ADDENDUM No. 1

Date **Friday April 10, 2026**

Project: **CommuniHealth Monroe
1205 Louisville Avenue
Monroe, LA 71201**

3 TYPICAL DETAIL WHERE CANOPY ROOF MEETS BALCONY WALL
SCALE: 1" = 1'-0"

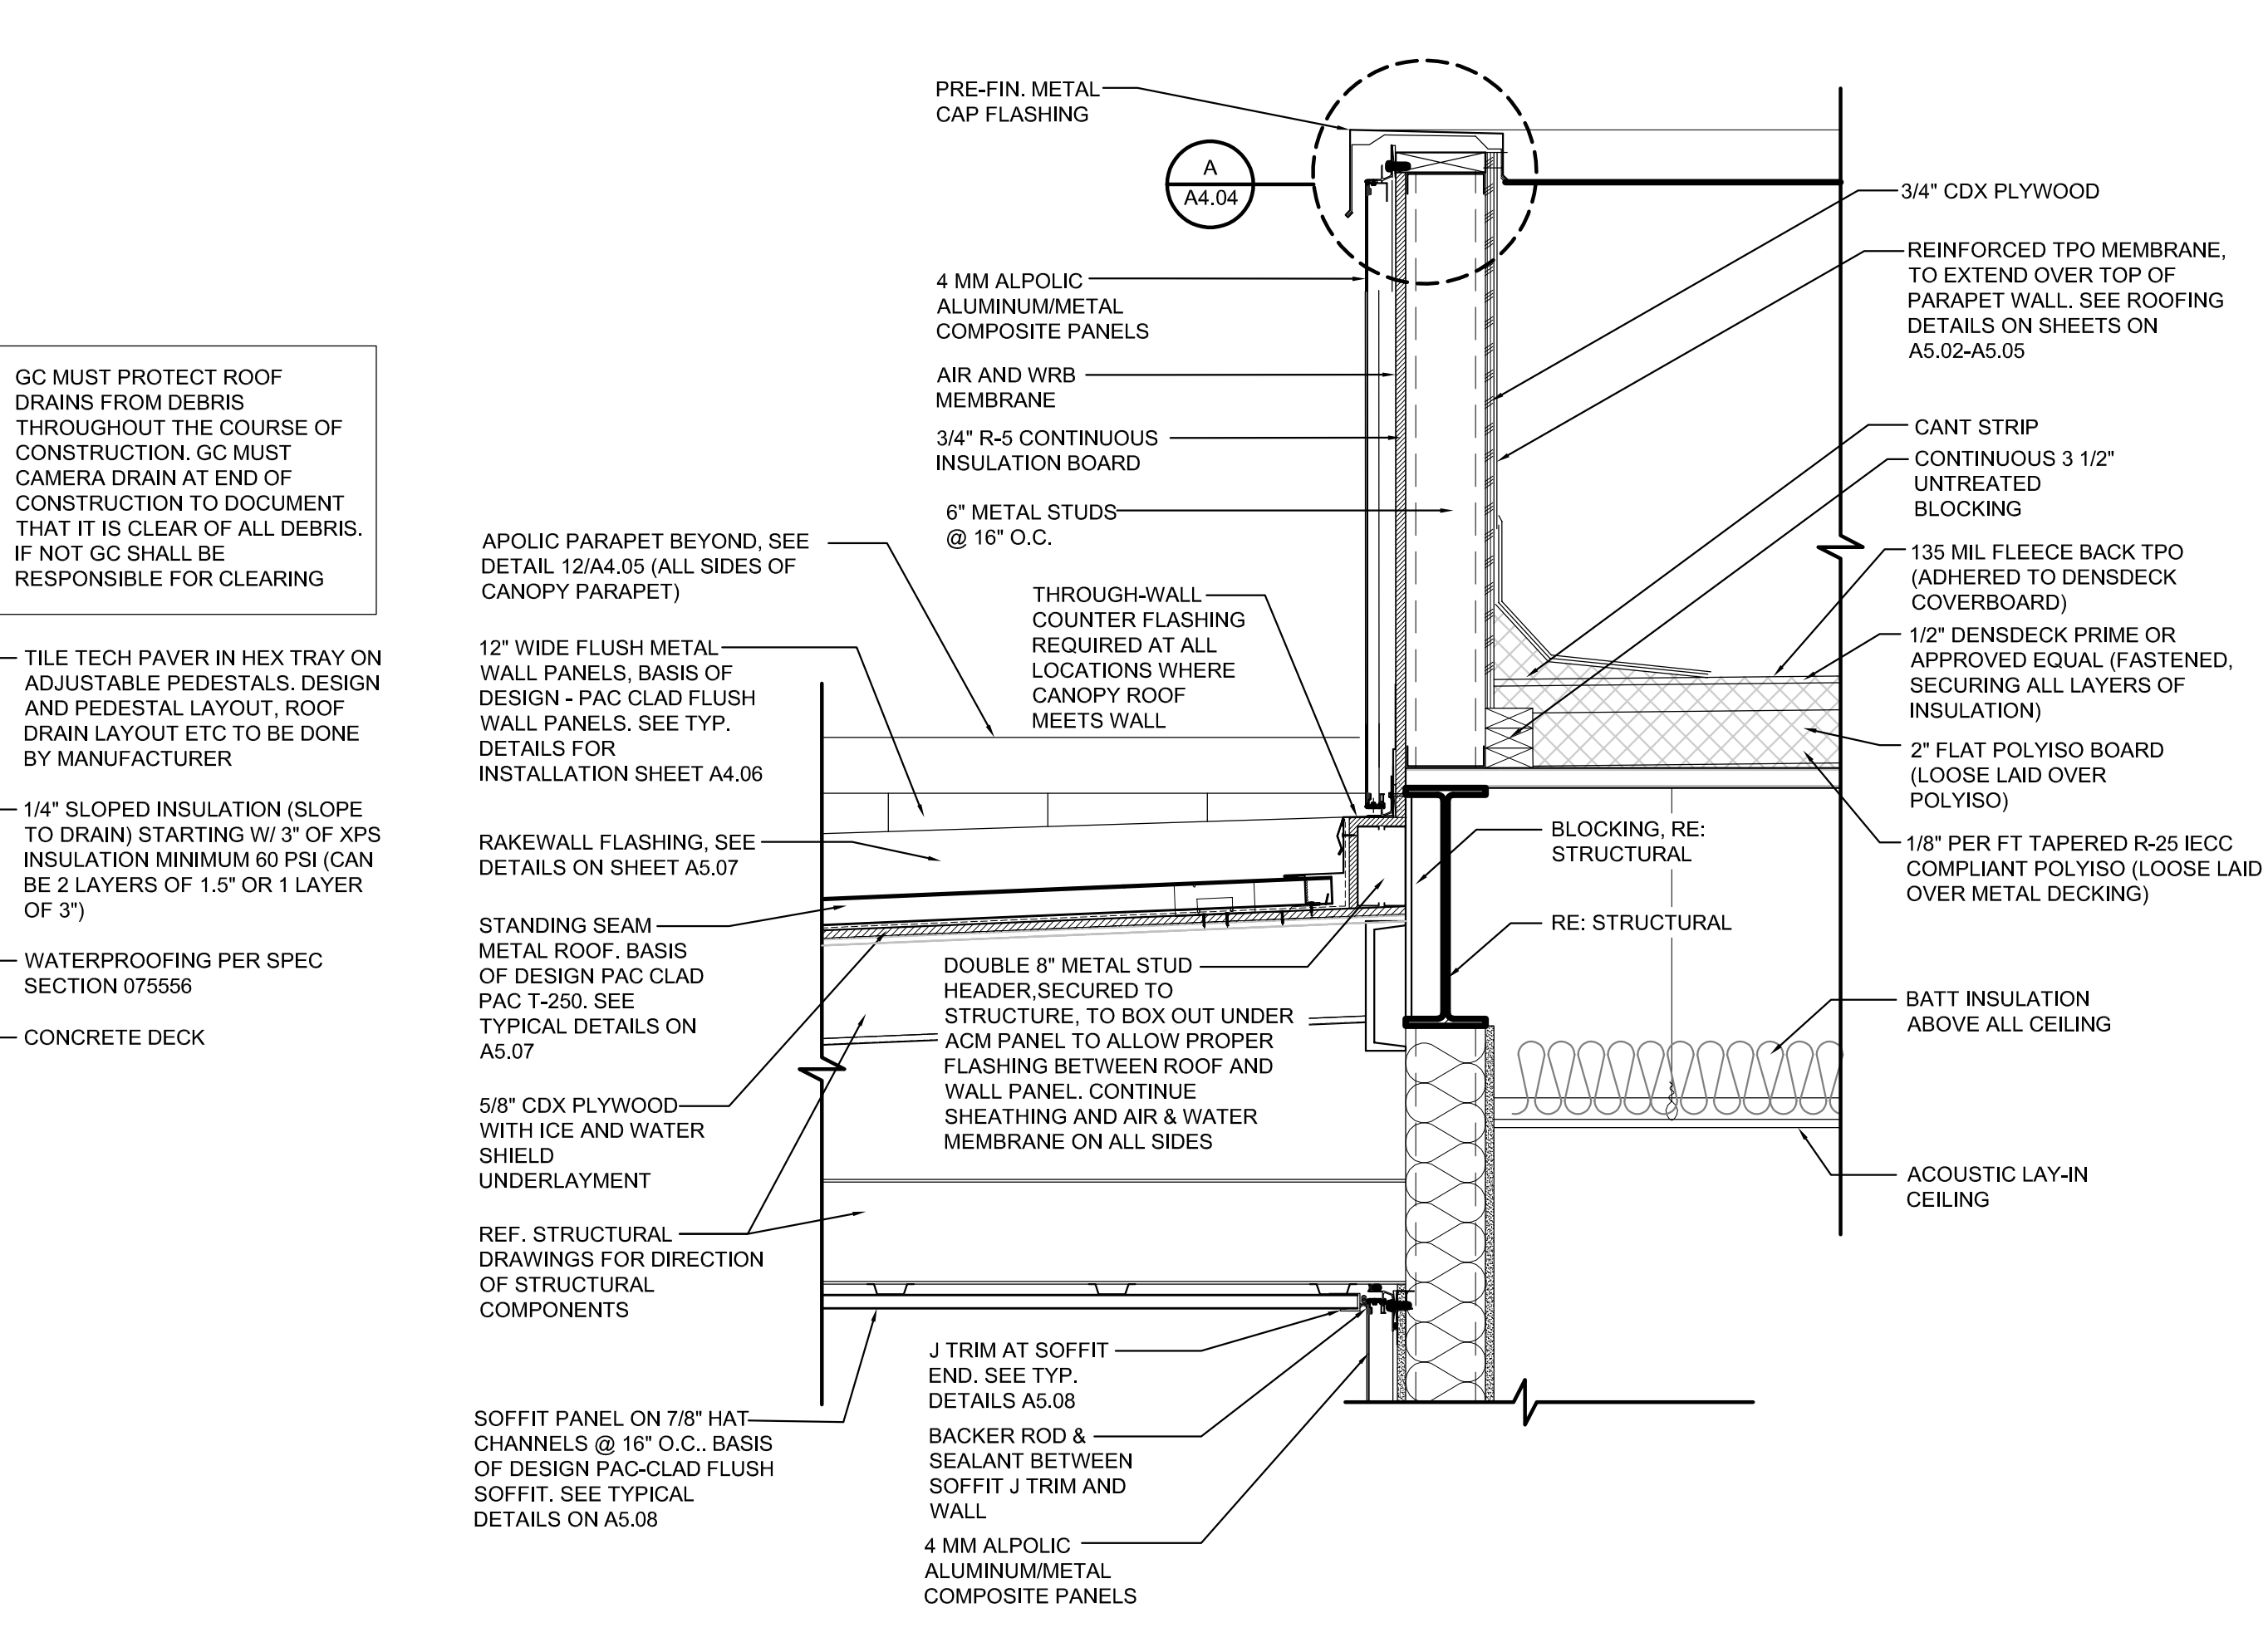
18. Balcony Columns – the intention is for the CMU around the columns to stop above the tile tech paver system. The CMU will have to be supported by a steel angle sized to support the CMU and tied back into the structural framing. The column framing will extend down to concrete deck and will receive the same wall sheathing and waterproofing like all exterior walls. The waterproofing and protection course at the balcony will extend up the structural framing at the columns similar to shown on detail 3/A4.02.

M2.02

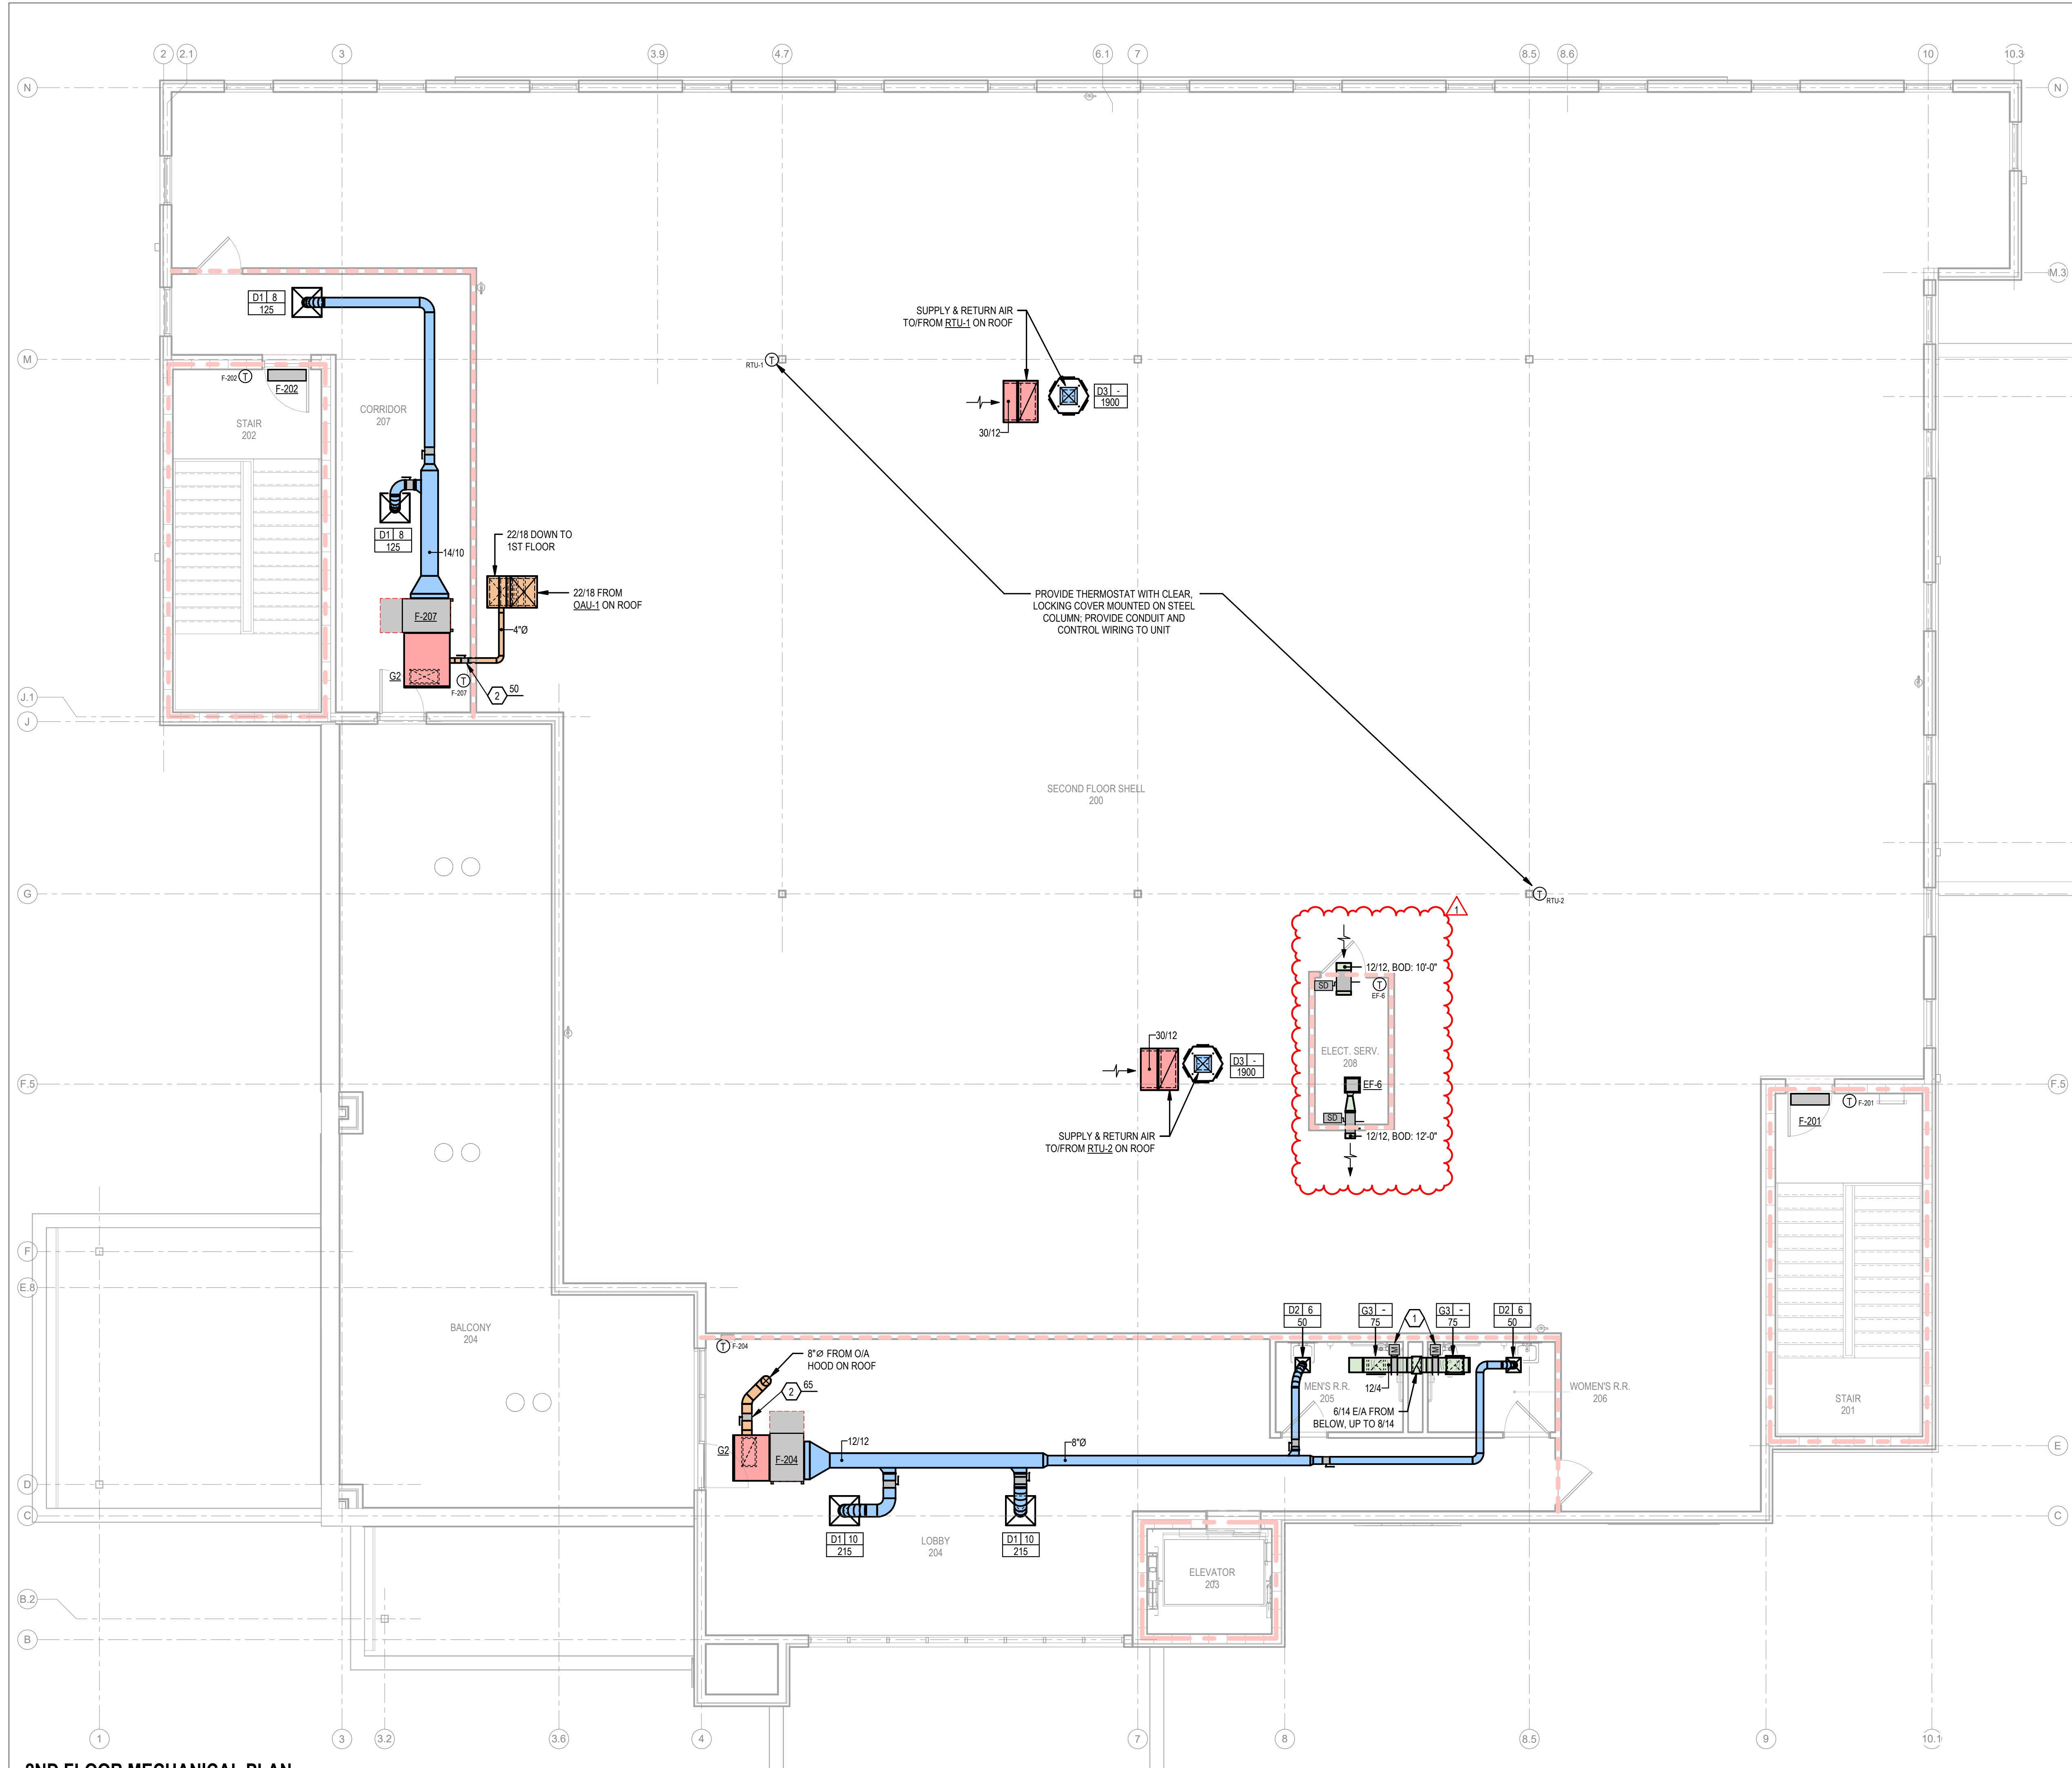
1. PROVIDE 120V MOTORIZED DAMPER WITH SLOW-OPENING ACTUATOR. INTERLOCK WITH LIGHTS AS REQUIRED FOR NORMALLY CLOSED DAMPER TO OPEN WHEN LIGHTS ARE ON (RE. ELECTRICAL PLANS).
2. BALANCE OUTSIDE AIR DUCT BRANCH TO NOTED AIRFLOW VALUE.
